Re: Cammeraygal High School - Response to Submissions

I have reviewed the submissions from Simon Elsy and Philip Ingevics concerning noise emission from the multi-purpose hall and have the following comments.

Figure 1 **Example monitoring results (see Report 17071 Appendix A)**

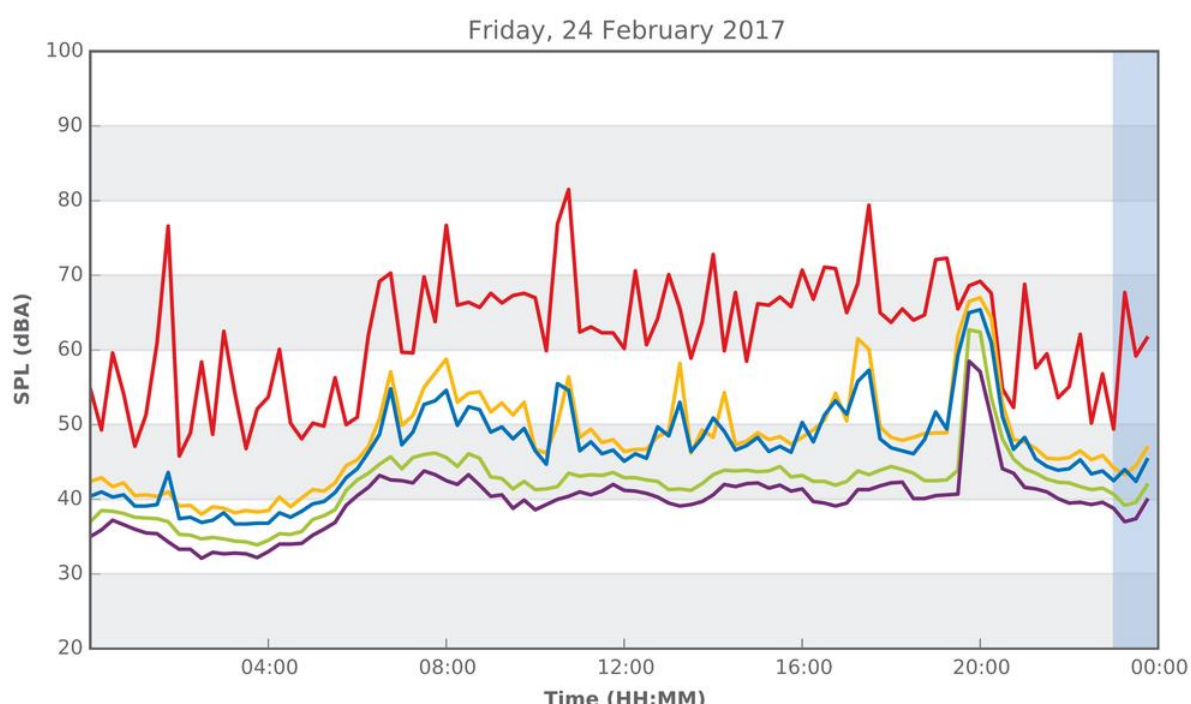
To help understand what this means, consider the following noise logger chart recorded at the site near the rear boundary. The chart is taken from the appendix to our DA report. The most important line to consider is the blue line which shows the $L_{Aeq,15min}$ minutes throughout the day. During the evening period from 6.00pm to 10.00pm on the example day and other days, the L_{Aeq} is typically 45 to 47dBA. (At this location there were some increases around 8.00pm to 60dBA, but these are excluded from our analysis.) The level recorded over 1 week of evenings was 52dBA as shown in Table 1.

The predicted level from the hall is similar to the existing environmental noise level in the area. So, while noise from the hall may be audible in the rooms facing the school, so will all the existing environmental noises that make up the background be audible – transportation, insects, wind in the trees etcetera. The intention of the noise policy is to reduce the new noise from the school to a level where it is not intrusive when compared to the existing noise environment.
